D70 MKII MODIFICATION INSTRUCTIONS

8/17/84

audio research corporation

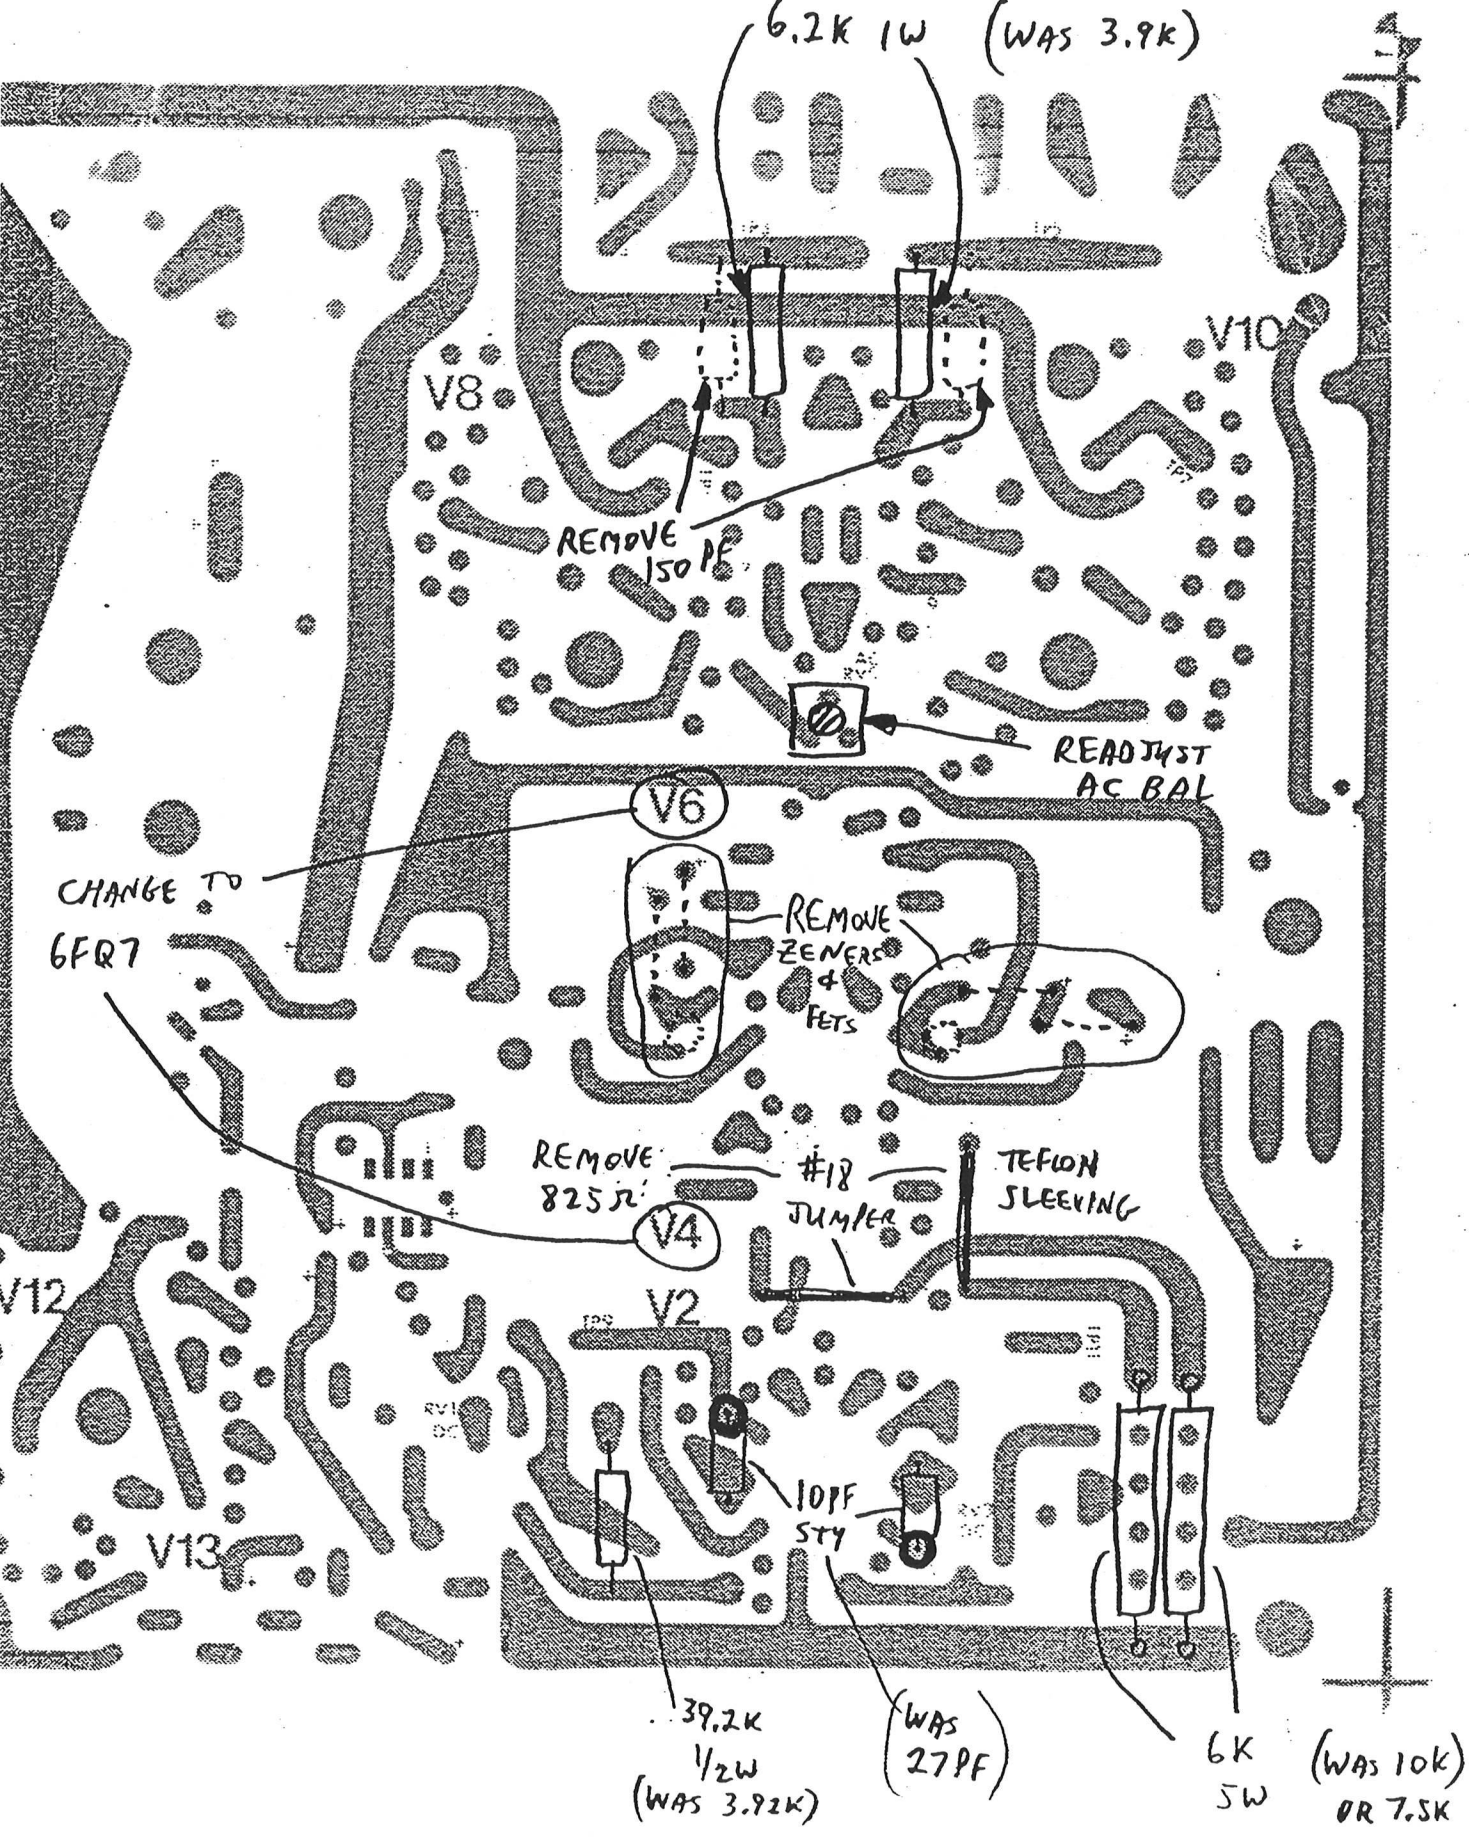
6.2K 1W (WAS 3.9K)

REMOVE
150 PF

CHANGE TO
6FR7

REMOVE
ZENERS
&
FETS

REMOVE
825R

#18
JUMPER

TEFLON
SLEEVING

10PF
STY

39.2K
1/2W
(WAS 3.92K)

(WAS
27PF)

6K
5W (WAS 10K
OR 7.5K)
